# ACCESSIBILITY ASSESSMENT

## ADA TITLE II ASSESSMENT

UNC Ackland Art Museum

*July 10, 2024*

# Ackland Art Museum BASEMENT

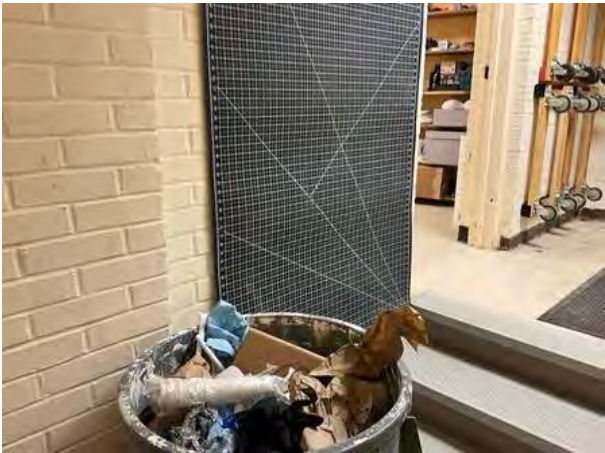
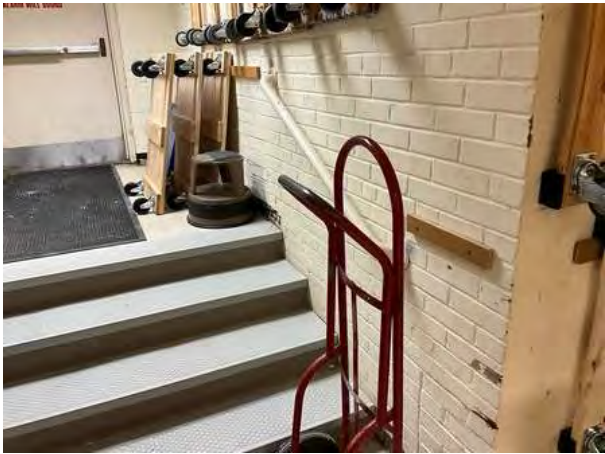
Assembly	Interior Access Route
Type	Stairs
ADA Standard	505
Barrier Detail	Handrails are not provided.
Location Description	Basement S-9
Observed	May 21, 2024 by Brian.rogers@bureauveritas.com

Handrail is not provided on the left side of the staircase. The existing handrail on the right side is 31 inches above the nose of the step and projects 5 inches from the bottom stairs and 3 inches at the top.

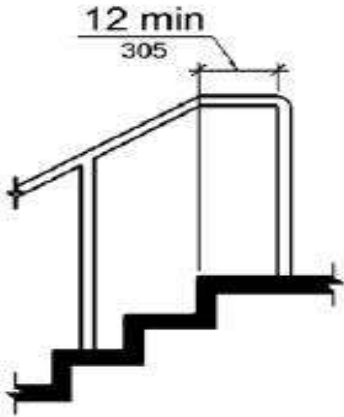
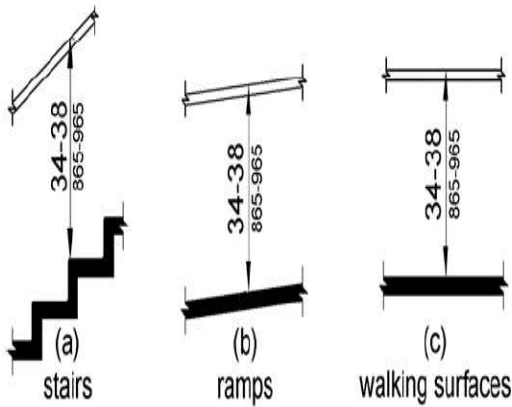
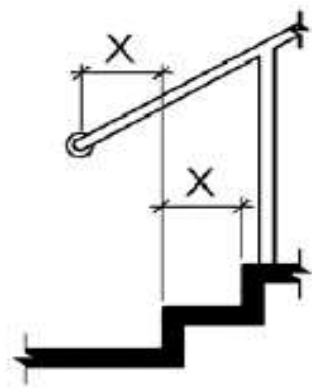
Assembly	Exterior Access Route
Type	Stairs
ADA Standard	505
Barrier Detail	Handrails are not compliant.
Location Description	Stairs on Colombia Street S-1
Observed	May 22, 2024 by Brian.rogers@bureauveritas.com

Handrails: Install compliant handrails on both sides of the stairway. Inside handrails on switchback or dogleg stairs shall be continuous between runs. Top of gripping surfaces of handrails shall be 34" minimum and 38" maximum vertically above stair nosings. Handrails shall be at a consistent height above ramp surfaces. Clearance between handrail gripping surfaces and adjacent surfaces shall be 1-1/2" minimum. Handrail gripping surfaces shall be continuous along their length and shall not be obstructed along their tops or sides. The bottoms of handrail gripping surfaces shall not be obstructed for more than 20% of their length. Where provided, horizontal projections shall occur 1-1/2" minimum below the bottom of the handrail gripping surface. [EXCEPTION: The distance between horizontal projections and the bottom of the gripping surface shall be permitted to be reduced by 1/8" for each 1/2" of additional handrail perimeter dimension that exceeds 4".] Handrail gripping surfaces with a circular cross section shall have an outside diameter of 1-1/4" minimum and 2" maximum. Handrail gripping surfaces with a non-circular cross section shall have a perimeter dimension of 4" minimum and 6-1/4" maximum, and a cross-section dimension of 2-1/4" maximum. Handrail gripping surfaces and any surfaces adjacent to them shall be free of sharp or abrasive elements and shall have rounded edges. Handrails shall not rotate within their fittings. Handrail gripping surfaces shall extend beyond and in the same direction of stair flights. [EXCEPTIONS: 1. Extensions shall not be required for continuous handrails at the inside turn of switchback or dogleg ramps AND 3. In alterations, full extensions of handrails shall not be required where such extensions would be hazardous due to plan configuration.] At the top of a stair flight, handrails shall extend horizontally above the landing for 12" minimum beginning directly above the first riser nosing. At the bottom of a stair flight, handrails shall extend at the slope of the stair flight for a horizontal distance at least equal to one tread depth beyond the last riser nosing. Extensions shall return to a wall, guard, or the landing surface, or shall be continuous to the handrail of an adjacent stair flight. Removal of this barrier is required if the stairs are part of the required accessible means of egress from the accessible space, per emergency egress plans approved by the administering local authority. [ADVISORY: It is advisable, but not required, to provide a handrail at a height designed for children. When children are the principal users in a building or facility (e.g., elementary schools), a second set of handrails at an appropriate height can assist them and aid in preventing accidents. A maximum height of 28" measured to the top of the gripping surface from the ramp surface or stair nosing is recommended for handrails designed for children. Sufficient vertical clearance between upper and lower handrails, 9" minimum, should be provided to help prevent entrapment.]

Map for Barrier ID: AX456209

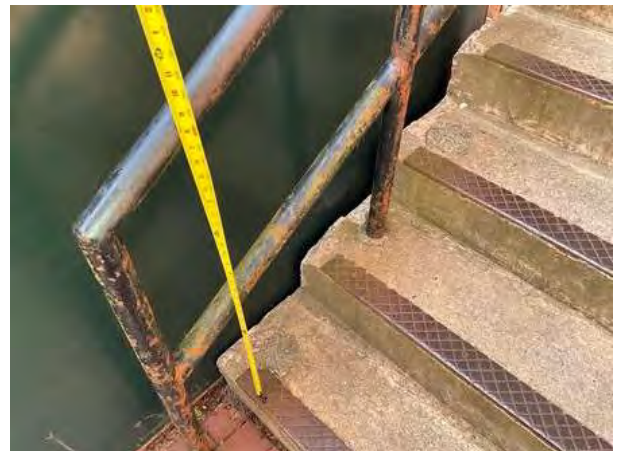
Assembly	Exterior Access Route
Type	Stairs
ADA Standard	505
Barrier Detail	Handrails are not compliant or are not provided.
Location Description	Stairs South Side. S-4
Observed	May 22, 2024 by Brian.rogers@bureauveritas.com

Install handrails on both sides of all stairs that comply with guidelines. Handrails shall be provided on both sides of stairs. Handrails shall be continuous within the full length of each stair flight or ramp run. Inside handrails on switchback or dogleg stairs and ramps shall be continuous between flights or runs. Top of gripping surfaces of handrails shall be 34" minimum and 38" maximum vertically above walking surfaces, stair nosings, and ramp surfaces. Handrails shall be at a consistent height above walking surfaces, stair nosings, and ramp surfaces. Clearance between handrail gripping surfaces and adjacent surfaces shall be 1-1/2" minimum. Handrail gripping surfaces shall be continuous along their length and shall not be obstructed along their tops or sides. The bottoms of handrail gripping surfaces shall not be obstructed for more than 20% of their length. Where provided, horizontal projections shall occur 1-1/2" minimum below the bottom of the handrail gripping surface. [EXCEPTIONS: 1. Where handrails are provided along walking surfaces with slopes not steeper than 1:20, the bottoms of handrail gripping surfaces shall be permitted to be obstructed along their entire length where they are integral to crash rails or bumper guards. 2. The distance between horizontal projections and the bottom of the gripping surface shall be permitted to be reduced by 1/8" for each 1/2" of additional handrail perimeter dimension that exceeds 4".] Handrail gripping surfaces with a circular cross section shall have an outside diameter of 1-1/4" minimum and 2" maximum. Handrail gripping surfaces with a non-circular cross section shall have a perimeter dimension of 4" minimum and 6-1/4" maximum, and a cross-section dimension of 2-1/4" maximum. Handrail gripping surfaces and any surfaces adjacent to them shall be free of sharp or abrasive elements and shall have rounded edges. Handrails shall not rotate within their fittings. Handrail gripping surfaces shall extend beyond and in the same direction of stair flights. At the top of a stair flight, handrails shall extend horizontally above the landing for 12" minimum beginning directly above the first riser nosing. At the bottom of a stair flight, handrails shall extend at the slope of the stair flight for a horizontal distance at least equal to one tread depth beyond the last riser nosing. Extensions shall return to a wall, guard, or the landing surface, or shall be continuous to the handrail of an adjacent stair flight. [EXCEPTIONS: 1. Extensions shall not be required for continuous handrails at the inside turn of switchback or dogleg stairs and ramps AND 3. In alterations, full extensions of handrails shall not be required where such extensions would be hazardous due to plan configuration.] [ADVISORY: It is advisable, but not required, to provide a handrail at a height designed for children. When children are the principal users in a building or facility (e.g., elementary schools), a second set of handrails at an appropriate height can assist them and aid in preventing accidents. A maximum height of 28" measured to the top of the gripping surface from the ramp surface or stair nosing is recommended for handrails designed for children. Sufficient vertical clearance between upper and lower handrails, 9" minimum, should be provided to help prevent entrapment.]

Map for Barrier ID: AX456211

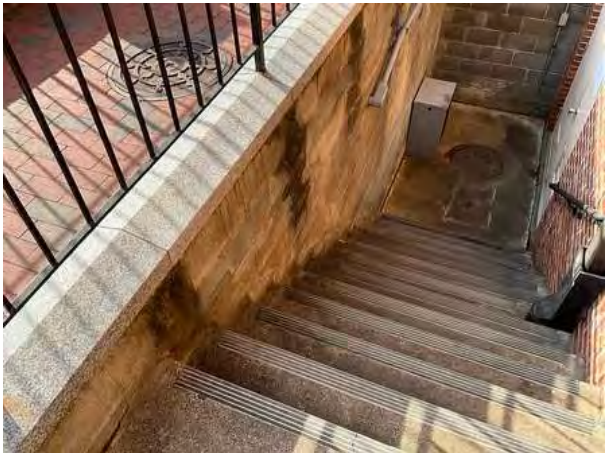
Assembly	Exterior Access Route
Type	Stairs
ADA Standard	505
Barrier Detail	Handrails are not compliant or are not provided.
Location Description	Stairs to Basement East Side S-6
Observed	May 22, 2024 by Brian.rogers@bureauveritas.com

Install handrails on both sides of all stairs that comply with guidelines. Handrails shall be provided on both sides of stairs. Handrails shall be continuous within the full length of each stair flight or ramp run. Inside handrails on switchback or dogleg stairs and ramps shall be continuous between flights or runs. Top of gripping surfaces of handrails shall be 34" minimum and 38" maximum vertically above walking surfaces, stair nosings, and ramp surfaces. Handrails shall be at a consistent height above walking surfaces, stair nosings, and ramp surfaces. Clearance between handrail gripping surfaces and adjacent surfaces shall be 1-1/2" minimum. Handrail gripping surfaces shall be continuous along their length and shall not be obstructed along their tops or sides. The bottoms of handrail gripping surfaces shall not be obstructed for more than 20% of their length. Where provided, horizontal projections shall occur 1-1/2" minimum below the bottom of the handrail gripping surface. [EXCEPTIONS: 1. Where handrails are provided along walking surfaces with slopes not steeper than 1:20, the bottoms of handrail gripping surfaces shall be permitted to be obstructed along their entire length where they are integral to crash rails or bumper guards. 2. The distance between horizontal projections and the bottom of the gripping surface shall be permitted to be reduced by 1/8" for each 1/2" of additional handrail perimeter dimension that exceeds 4".] Handrail gripping surfaces with a circular cross section shall have an outside diameter of 1-1/4" minimum and 2" maximum. Handrail gripping surfaces with a non-circular cross section shall have a perimeter dimension of 4" minimum and 6-1/4" maximum, and a cross-section dimension of 2-1/4" maximum. Handrail gripping surfaces and any surfaces adjacent to them shall be free of sharp or abrasive elements and shall have rounded edges. Handrails shall not rotate within their fittings. Handrail gripping surfaces shall extend beyond and in the same direction of stair flights. At the top of a stair flight, handrails shall extend horizontally above the landing for 12" minimum beginning directly above the first riser nosing. At the bottom of a stair flight, handrails shall extend at the slope of the stair flight for a horizontal distance at least equal to one tread depth beyond the last riser nosing. Extensions shall return to a wall, guard, or the landing surface, or shall be continuous to the handrail of an adjacent stair flight. [EXCEPTIONS: 1. Extensions shall not be required for continuous handrails at the inside turn of switchback or dogleg stairs and ramps AND 3. In alterations, full extensions of handrails shall not be required where such extensions would be hazardous due to plan configuration.] [ADVISORY: It is advisable, but not required, to provide a handrail at a height designed for children. When children are the principal users in a building or facility (e.g., elementary schools), a second set of handrails at an appropriate height can assist them and aid in preventing accidents. A maximum height of 28" measured to the top of the gripping surface from the ramp surface or stair nosing is recommended for handrails designed for children. Sufficient vertical clearance between upper and lower handrails, 9" minimum, should be provided to help prevent entrapment.]

Map for Barrier ID: AX456208

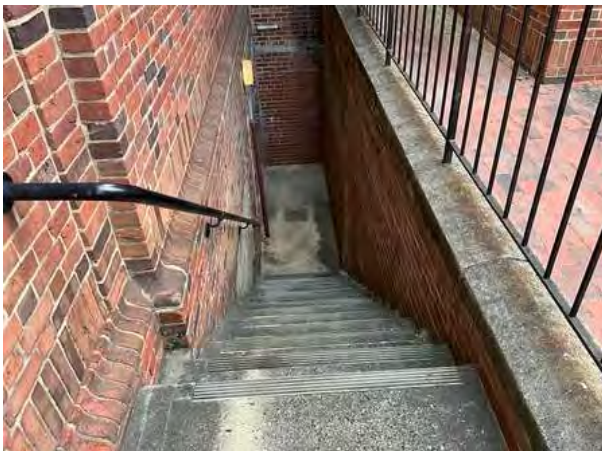
Assembly	Exterior Access Route
Type	Stairs
ADA Standard	505
Barrier Detail	Handrails are not compliant or are not provided.
Location Description	Stairs to Basement S-3
Observed	May 22, 2024 by Brian.rogers@bureauveritas.com

Install handrails on both sides of all stairs that comply with guidelines. Handrails shall be provided on both sides of stairs. Handrails shall be continuous within the full length of each stair flight or ramp run. Inside handrails on switchback or dogleg stairs and ramps shall be continuous between flights or runs. Top of gripping surfaces of handrails shall be 34" minimum and 38" maximum vertically above walking surfaces, stair nosings, and ramp surfaces. Handrails shall be at a consistent height above walking surfaces, stair nosings, and ramp surfaces. Clearance between handrail gripping surfaces and adjacent surfaces shall be 1-1/2" minimum. Handrail gripping surfaces shall be continuous along their length and shall not be obstructed along their tops or sides. The bottoms of handrail gripping surfaces shall not be obstructed for more than 20% of their length. Where provided, horizontal projections shall occur 1-1/2" minimum below the bottom of the handrail gripping surface. [EXCEPTIONS: 1. Where handrails are provided along walking surfaces with slopes not steeper than 1:20, the bottoms of handrail gripping surfaces shall be permitted to be obstructed along their entire length where they are integral to crash rails or bumper guards. 2. The distance between horizontal projections and the bottom of the gripping surface shall be permitted to be reduced by 1/8" for each 1/2" of additional handrail perimeter dimension that exceeds 4".] Handrail gripping surfaces with a circular cross section shall have an outside diameter of 1-1/4" minimum and 2" maximum. Handrail gripping surfaces with a non-circular cross section shall have a perimeter dimension of 4" minimum and 6-1/4" maximum, and a cross-section dimension of 2-1/4" maximum. Handrail gripping surfaces and any surfaces adjacent to them shall be free of sharp or abrasive elements and shall have rounded edges. Handrails shall not rotate within their fittings. Handrail gripping surfaces shall extend beyond and in the same direction of stair flights. At the top of a stair flight, handrails shall extend horizontally above the landing for 12" minimum beginning directly above the first riser nosing. At the bottom of a stair flight, handrails shall extend at the slope of the stair flight for a horizontal distance at least equal to one tread depth beyond the last riser nosing. Extensions shall return to a wall, guard, or the landing surface, or shall be continuous to the handrail of an adjacent stair flight. [EXCEPTIONS: 1. Extensions shall not be required for continuous handrails at the inside turn of switchback or dogleg stairs and ramps AND 3. In alterations, full extensions of handrails shall not be required where such extensions would be hazardous due to plan configuration.] [ADVISORY: It is advisable, but not required, to provide a handrail at a height designed for children. When children are the principal users in a building or facility (e.g., elementary schools), a second set of handrails at an appropriate height can assist them and aid in preventing accidents. A maximum height of 28" measured to the top of the gripping surface from the ramp surface or stair nosing is recommended for handrails designed for children. Sufficient vertical clearance between upper and lower handrails, 9" minimum, should be provided to help prevent entrapment.]

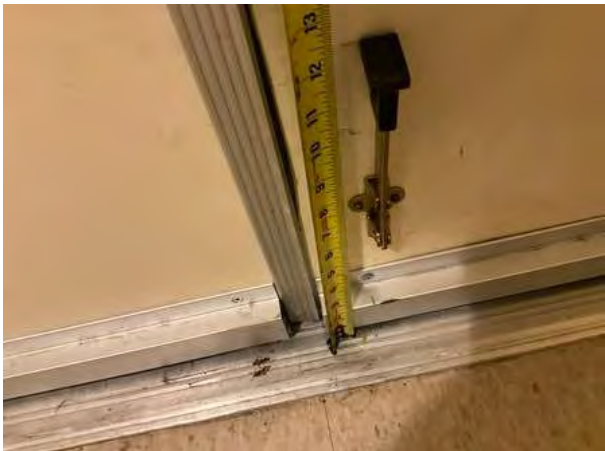
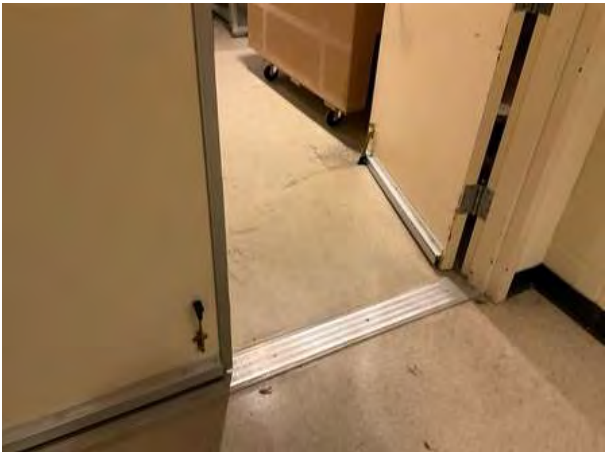
Location Description	All Basement doors
Observed	May 21, 2024 by Brian.rogers@bureauveritas.com

Doors in the basement have hold open devices mounted in the first 10 inches of the doors. for 20 doors

Modify or replace the door to provide a smooth surface on the door within 10 inches of the finish floor or ground for the full width of the door on the push side. Parts creating horizontal or vertical joints in these surfaces shall be within 1/16 inch of the same plane as the other and be free of sharp or abrasive edges. Cavities created by added kick plates shall be capped.Swinging door and gate surfaces within 10 inches of the finish floor or ground measured vertically shall have a smooth surface on the push side extending the full width of the door or gate. Parts creating horizontal or vertical joints in these surfaces shall be within 1/16 inch of the same plane as the other. Cavities created by added kick plates shall be capped. [EXCEPTIONS: 1. Sliding doors shall not be required to comply. 2. Tempered glass doors without stiles and having a bottom rail or shoe with the top leading edge tapered at 60 degrees minimum from the horizontal shall not be required to meet the 10 inch bottom smooth surface height requirement. 3. Doors and gates that do not extend to within 10 inches of the finish floor or ground shall not be required to comply. 4. Existing doors and gates without smooth surfaces within 10 inches of the finish floor or ground shall not be required to provide smooth surfaces provided that if added kick plates are installed, cavities created by such kick plates are capped.]

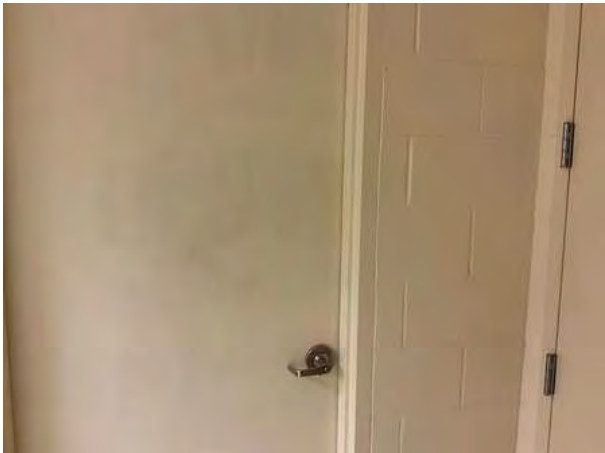
Assembly	Interior Access Route	
Type	Signage	
ADA Standard	703.4	
Barrier Detail		
The existing signage is not mounted at the latch side of the door or at a compliant height.		
Location Description	All Basemet Rooms	
Observed	May 21, 2024 by Brian.rogers@bureauveritas.com	
Site Conditions	All rooms do not have proper signage.	
Resolution		
Remove and remount signage alongside the latch side of the door mounted at compliant height. Tactile characters on signs shall be located 48" minimum above the finish floor or ground surface, measured from the baseline of the lowest tactile character and 60" maximum above the finish floor or ground surface, measured from the baseline of the highest tactile character. [EXCEPTION: Tactile characters for elevator car controls shall not be required to comply.] Where a tactile sign is provided at a door, the sign shall be located alongside the door at the latch side. Where a tactile sign is provided at double doors with one active leaf, the sign shall be located on the inactive leaf. Where a tactile sign is provided at double doors with two active leafs, the sign shall be located to the right of the right hand door. Where there is no wall space at the latch side of a single door or at the right side of double doors, signs shall be located on the nearest adjacent wall. Signs containing tactile characters shall be located so that a clear floor space of 18" minimum by 18" minimum, centered on the tactile characters, is provided beyond the arc of any door swing between the closed position and 45 degree open position [EXCEPTION: Signs with tactile characters shall be permitted on the push side of doors with closers and without hold-open devices.]

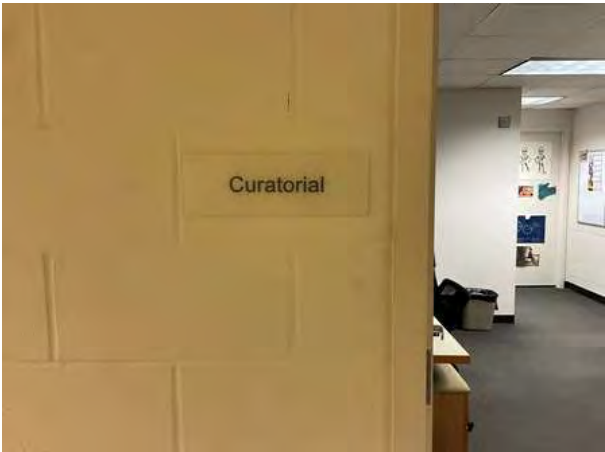
Site Conditions	Signage does not have raised characters or braille.
-----------------	---

Remove and replace signage with compliant signage. Raised characters shall be compliant and shall be duplicated in Braille. Raised characters shall be as follows: Depth: Raised characters shall be 1/32" minimum above their background. Case: Characters shall be uppercase. Style: Characters shall be sans serif. Characters shall not be italic, oblique, script, highly decorative, or of other unusual forms. Character Proportions: Characters shall be selected from fonts where the width of the uppercase letter "O" is 55 % minimum and 110 % maximum of the height of the uppercase letter "I". Character Height: Character height measured vertically from the baseline of the character shall be 5/8" minimum and 2" maximum based on the height of the uppercase letter "I". [EXCEPTION: Where separate raised and visual characters with the same information are provided, raised character height shall be permitted to be 1/2" minimum.] Tactile characters on signs shall be located 48" minimum above the finish floor or ground surface, measured from the baseline of the lowest tactile character and 60" maximum above the finish floor or ground surface, measured from the baseline of the highest tactile character. Where a tactile sign is provided at a door, the sign shall be located alongside the door at the latch side. Where a tactile sign is provided at double doors with one active leaf, the sign shall be located on the inactive leaf. Where a tactile sign is provided at double doors with two active leafs, the sign shall be located to the right of the right hand door. Where there is no wall space at the latch side of a single door or at the right side of double doors, signs shall be located on the nearest adjacent wall. Signs containing tactile characters shall be located so that a clear floor space of 18" minimum by 18" minimum, centered on the tactile characters, is provided beyond the arc of any door swing between the closed position and 45 degree open position. [EXCEPTION: Signs with tactile characters shall be permitted on the push side of doors with closers and without hold-open devices.]

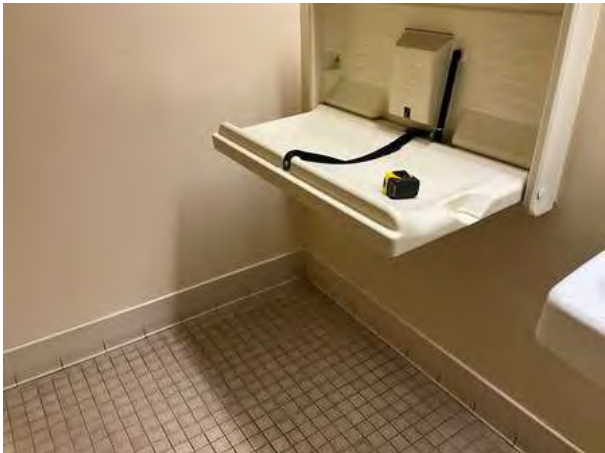
When open, the baby changing table is mounted 35 1/2 inches above the finish floor.

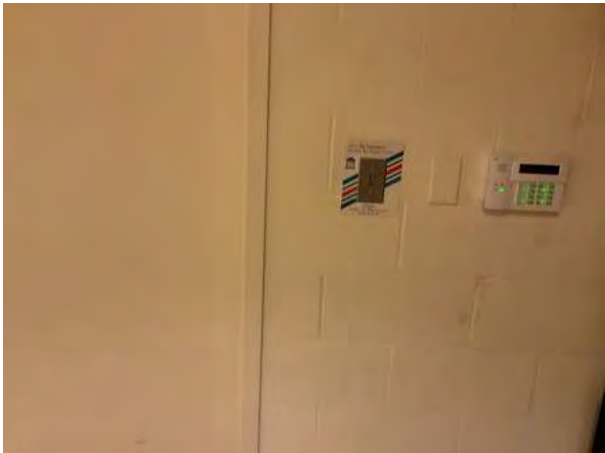
Items requiring an unobstructed forward reach motion are higher than 48" maximum or lower than 15" minimum height above finish floor.

Location Description	Light Switches
Observed	May 21, 2024 by Brian.rogers@bureauveritas.com
Site Conditions	Light switches are between 49" and 52" and comply with 1992 standards.

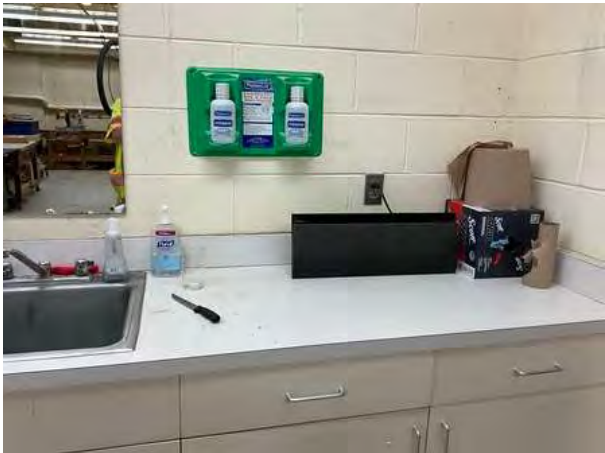
The counter is 25 inches wide is 54 inches to the bottom of the eyewash station.

Remove/redesign obstruction or redesign element to allow clear floor space beneath the obstruction for the full reach depth. Where a forward reach is obstructed, clear floor space shall extend beneath the element for a distance not less than the required reach depth over the obstruction. The high forward reach shall be 48" maximum where the reach depth is 20" maximum. Where the reach depth exceeds 20", the high forward reach shall be 44" maximum and the reach depth shall be 25" maximum.

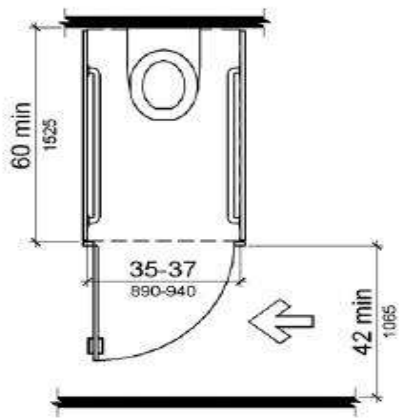
The ambulatory stall size is not compliant, or an ambulatory stall is not provided.

<b>Location Description</b>	Basement Men's Restroom
<b>Observed</b>	May 21, 2024 by Brian.rogers@bureauveritas.com
<b>Site Conditions</b>	The ambulatory stall is 38 1/2 inches wide by 71 inches deep.

Provide a compliant ambulatory stall, where six or more toilet compartments are provided or where the combination of urinals and water closets totals six or more fixtures. An ambulatory stall is minimum 60" deep and the width is minimum 35" and maximum 37". Grab bars shall be provided on both sides of the compartment. The side grab bars shall be 33" minimum to 36" maximum above finish floor to the top of the gripping surface, except in children's (ages 3-12) water closets where horizontal grab bars shall be 18" minimum and 27" maximum above the finish floor to the top of the gripping surface. Horizontal grab bars should be installed at a consistent height. The side wall grab bars shall be 42" long minimum, located 12" maximum from the rear wall and extending 54" minimum from the rear wall. The centerline of the toilet shall be minimum 17" to maximum 19" from the side wall. Toilet compartment doors for ambulatory stalls shall be minimum 32" wide when open 90 degrees and have minimum 80" high clearance. If the approach is to the latch side of the compartment door, clearance between the exterior side of the door of the compartment and any obstruction shall be 42" minimum. The door shall be self-closing. A compliant door pull shall be placed on both sides of the door near the latch. Toilet compartment doors shall not swing into the minimum required compartment area. [ADVISORY: It is advisable, but not required, to use the specifications for children where children are the primary users of the restroom. Guidance in applying the specifications for children according to the age group served reflects the differences in the size, stature, and reach ranges of children ages 3 to 12. The specifications chosen should correspond to the age of the primary user group. The specifications of one age group should be applied consistently in the installation of a water closet and related elements. Water Closet Centerline: Ages 3 and 4- 12"; Ages 5 through 8- 12" to 15"; Ages 9 through 12- 15" to 18". Toilet Seat Height: Ages 3 and 4- 11" to 12"; Ages 5 through 8- 12" to 15"; Ages 9 through 12- 15" to 17". Grab Bar Height: Ages 3 and 4- 18" to 20"; Ages 5 through 8- 20" to 25"; Ages 9 through 12- 25" to 27"; Dispenser Height: Ages 3 and 4- 14"; Ages 5 through 8- 14" to 17"; Ages 9 through 12- 17" to 19".]
